126 LANGDON STREET BUILDING PROPOSAL

Comments on application for 126 Langdon St Bob Klebba 8 March 2021

Plan Commission Meeting of March 8, 2021 Agenda #11, Legistar #63476

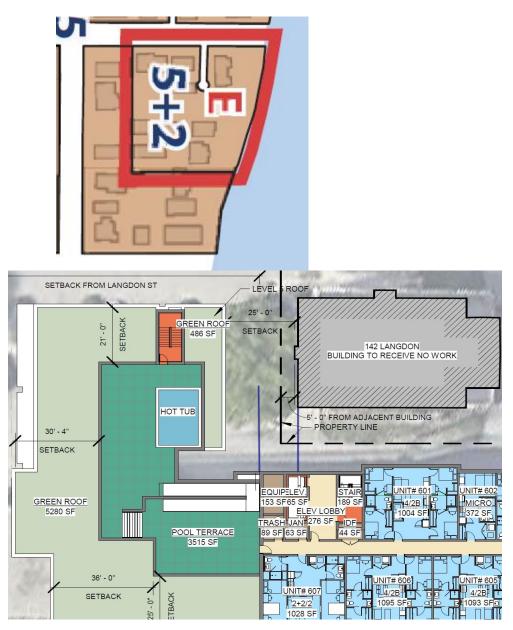
Page A28 is a visual from the Downtown Plan showing additional height areas, and is a bit fuzzy as to the actual line. What is clearer is the "Maximum Building Heights" map from the 2012 downtown plan materials. The 2012 map outlines in black lines the area for additional height, and then draws a red box around that outline (see below, with the additional height area rotated to the same orientation as the project plans). Note that the line parallel to Langdon runs along the back of 142 Langdon.

The second image is from page A17 of the plans with blue lines added from the back of 142 Langdon (the edge of the additional height map) and from the edge of the 6^{th} story. The 6^{th} and 7^{th} stories are approximately 13 feet too close to Langdon.
